Staff Report to the Planning Commission - 3019 N. Argonne Siding Exception Request

INTERIOR & EXTERIOR REMODEL FOR:
MARK BAUER
3019 N. ARGONNE MILLWOOD, WA

**ATTACHMENT #3: MW-2026-0021 - Baier Plan Revised (8-11-26) -
Pending Millwood Planning Commission Approval or Denial**

A-3

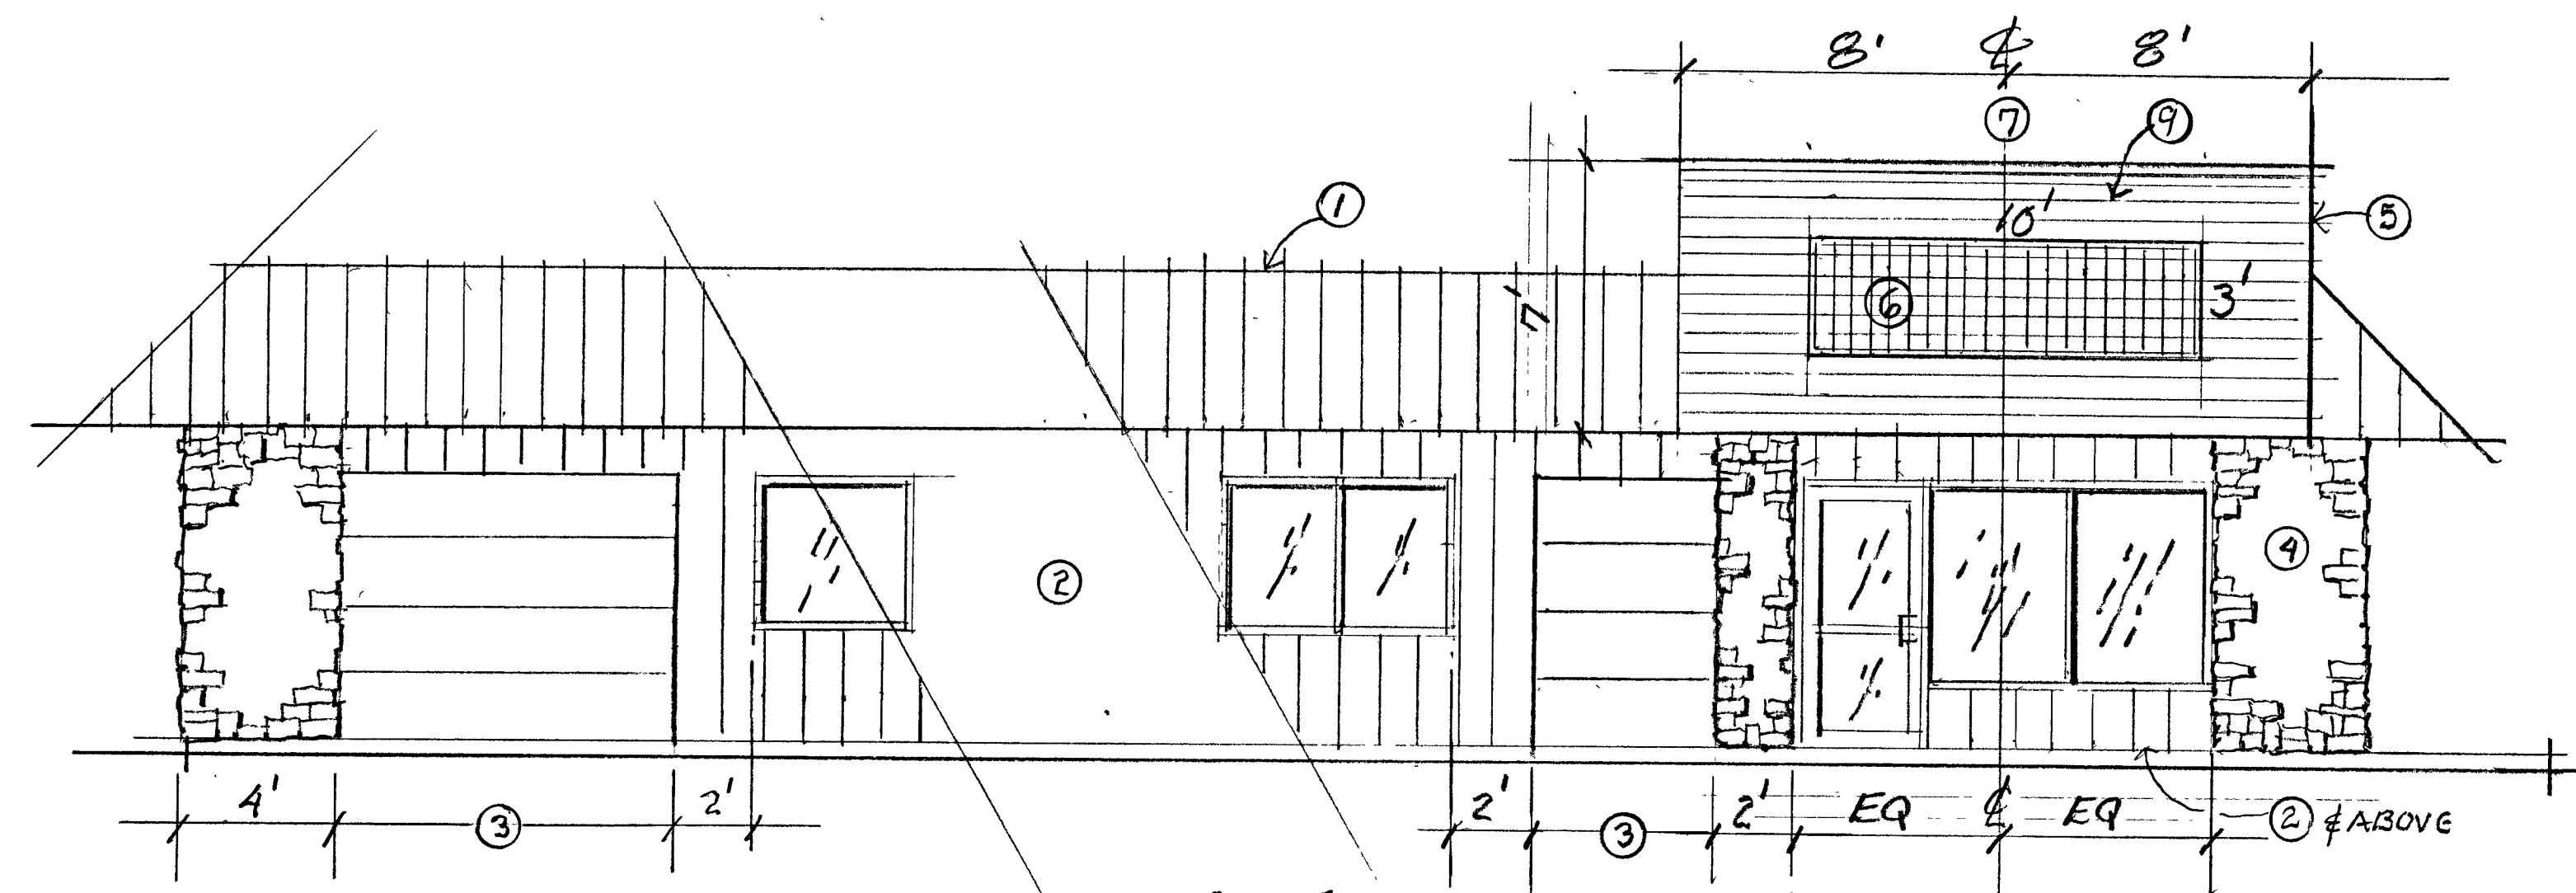
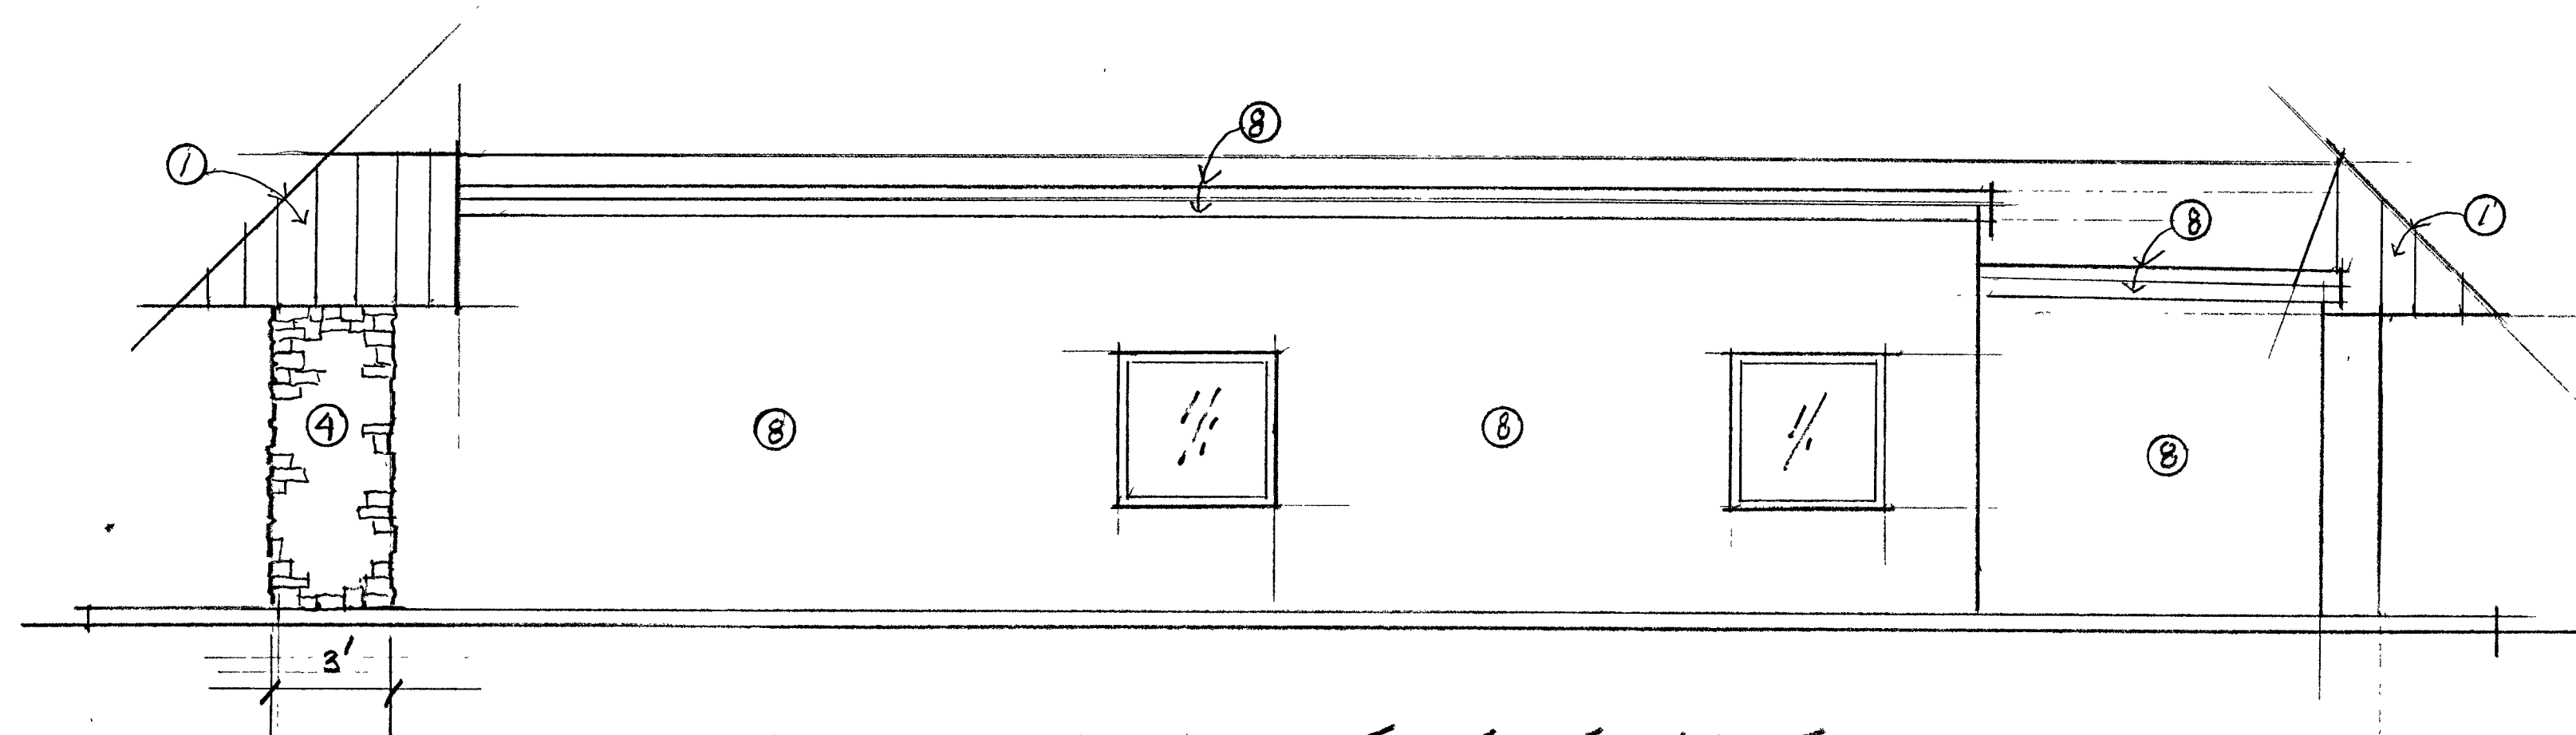
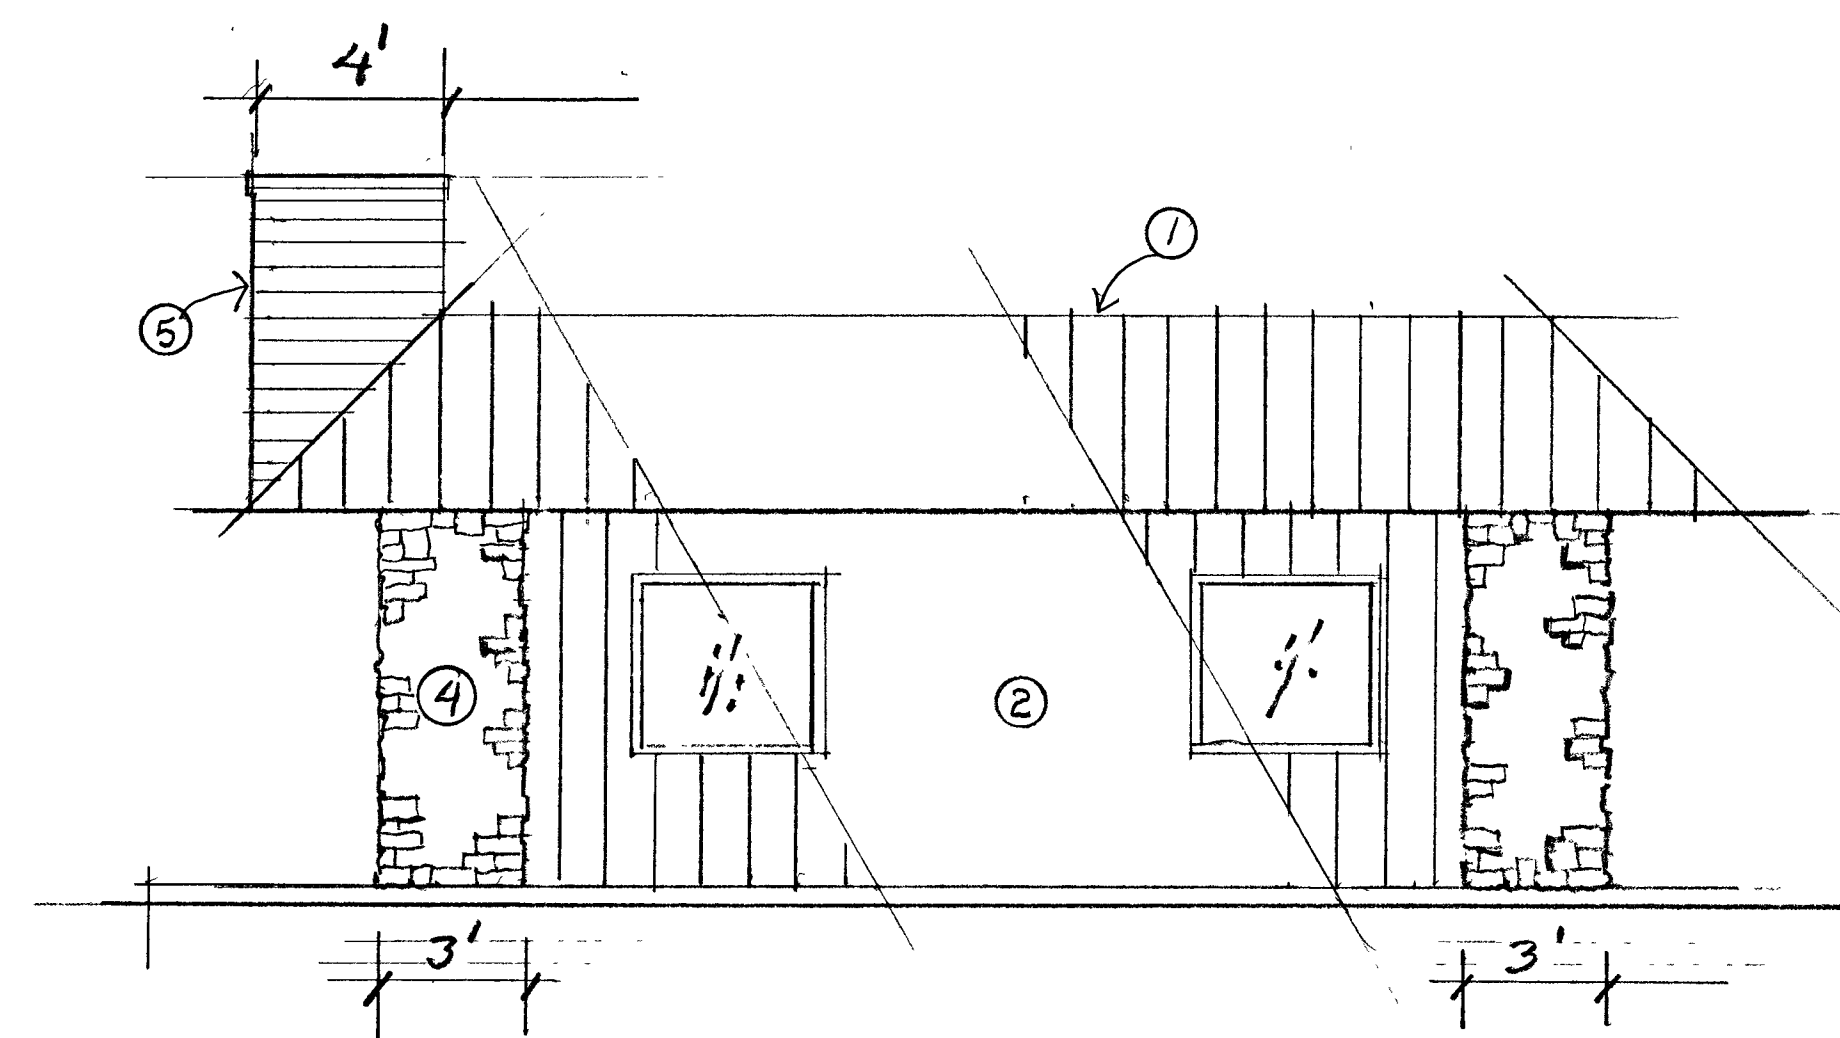
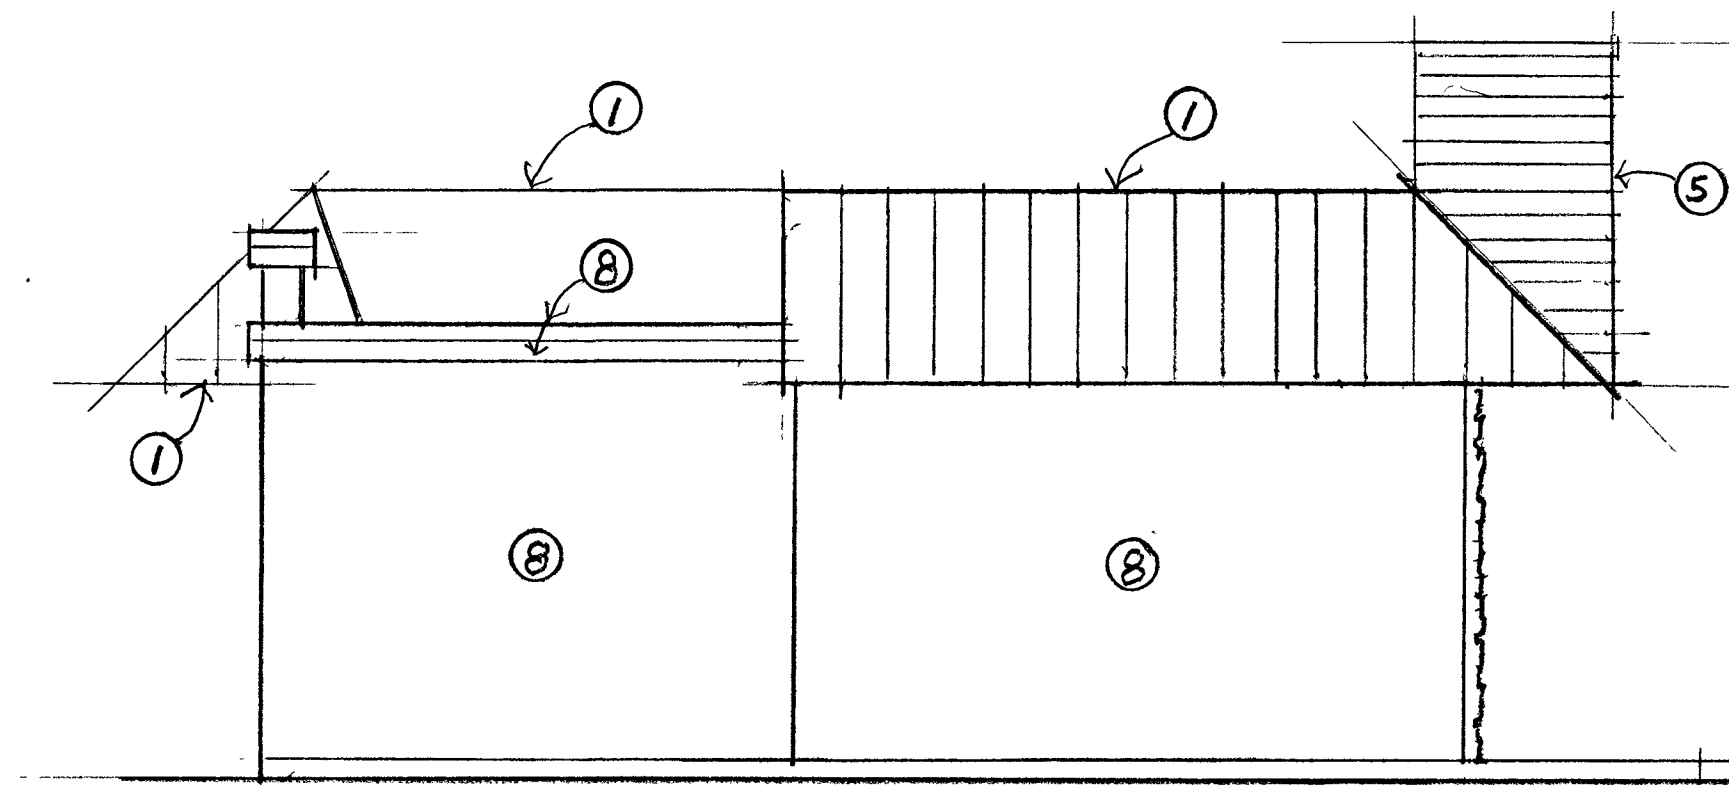
- During the project review, the City of Millwood requested revision of the siding material since it was listed as metal, which is not an approved siding material in the C-2 Zone. Amanda Tainio, Contract City Planner, noted the planning review as deficient in Spokane Valley SmartGov since the project was proposing to utilize metal siding and left a voicemail for the contractor notifying him that metal siding is not allowed in C-2 and must be switched to an allowed material.

- ① METAL ROOFING
- ② METAL SIDING - SEE ELEVATION NOTE ⑩
- ③ CEMENT SIDING PANEL
- ④ TEXTURED CEMENT STONE VENEER-TYP
- ⑤ HORIZONTAL METAL PANEL
- ⑥ FRAMED METAL WIRE MESH SIGN PANEL
- ⑦ CENTER ON AL & GL STOREFRONT.
- ⑧ PAINT
- ⑨ SEE STRUCTURAL ENG. FOR RAISED SIGN FRAMING & SUPPORT
- ⑩ SEE REQUEST FOR WAIVER - METAL SIDING REQUIREMENT MILLWOOD C-2 ZONE PER MMC 17.24.010(F) LETTER FROM GERALD KOFMEHL DATED 5/27/26 ON SHEET A-4 DATED 8/10/26

Δ REQUEST FOR WAIVER LETTER ADDED ON SHEET A-4 DATED 8/10/26

Deviation from the approved plans for MW-2026-0021. The metal siding is not permitted per MMC 17.24.010 - Development standards. Cement siding panels were approved and listed on the approved plans in lieu of proposed metal. Building must comply with the approved plans and building permit issued for MW-2026-0021.
